Attachment 3 to U-602499 LS-95-013 Page 1 of 3

Attached Marked-Up Pages of the Technical Specifications

3.4.2 Flow Control Valves (FCVs)

Technical Specification Bases Changes

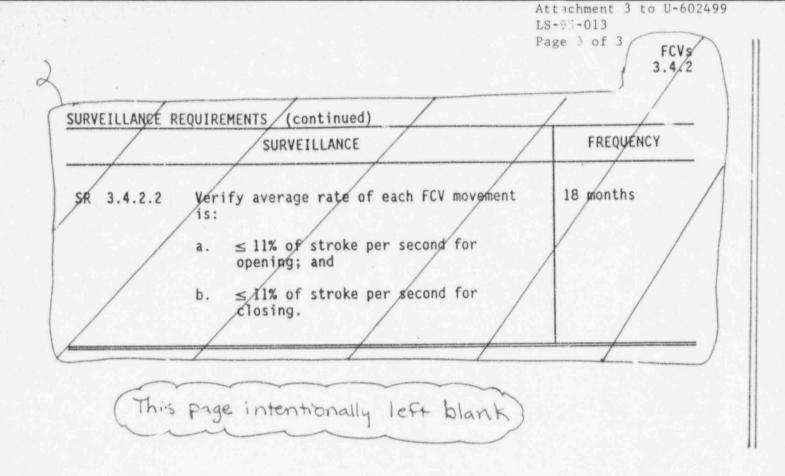
LCO 3.4.2 A recirculation loop FCV shall be OPERABLE in each operating recirculation loop.

APPLICABILITY: MODES 1 and 2.

FREQUENCY	
SR 3.4.2.1	Verify each FCV fails "as is" on loss of hydraulic pressure at the hydraulic unit.	18 months
		(continued) *
